Work Order ID 100352

Item Name: Replacement Skidtube

DRAWING NO. D2650	TITLE 206/407 SKIDTUBE ASSEMBLIES	REV F	DART AEROSPACE LTD ENGINEERING ORDER		DE O. NO. D2650-F-1	SHEET NO. SHEET 1 OF 1
DRAWN [Signature]	CHECKED A.P.	MFG. APPR [Signature]	APPROVED [Signature]	DE APPR [Signature]		
DATE 12.10.12	DATE 12.10.22	DATE 12.10.22	DATE 12.10.22	DATE 12.10.22	DATE 12.10.22

CHANGE C'BORED WELDED CROSSBOLT SPACERS TO SWAGED SPACERS

IS:

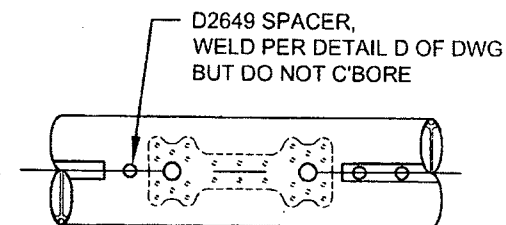
PARTS LIST IS AMENDED AS FOLLOWS:

QTY -1	QTY -3	QTY -5	QTY -7	PART NUMBER	DESCRIPTION
1	1	0	0	D2649	CROSS BOLT SPACER
16	17	19	23	D4720-1	SPACER

**DETAIL B**

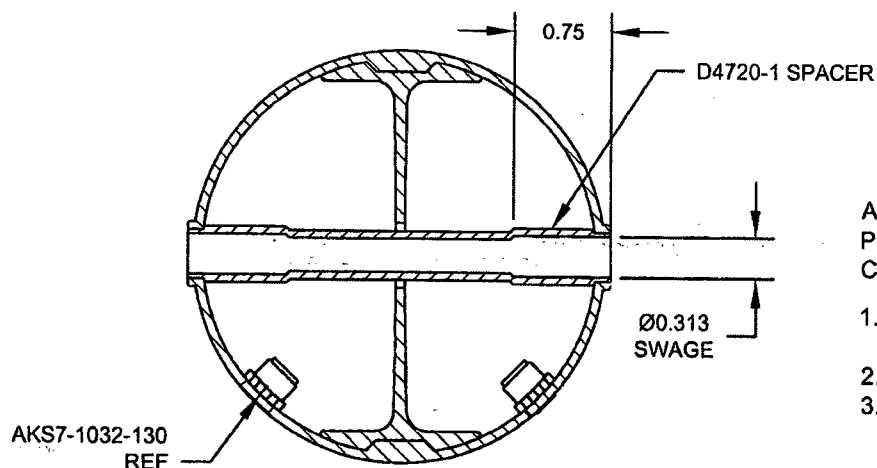
ADD DETAIL G BELOW, WHICH IS THE SAME SECTION VIEW AS DETAIL D OF DWG.

C'BORED HOLES ARE **NOW SWAGED** PER DETAIL G BELOW. FOR THE Ø0.375 HOLE THAT IS NOT C'BORED, WELD PER DETAIL D OF DWG (SEE AMENDED DETAIL B FOR REFERENCE).

AMENDMENT TO DETAIL B  
NOT TO SCALE
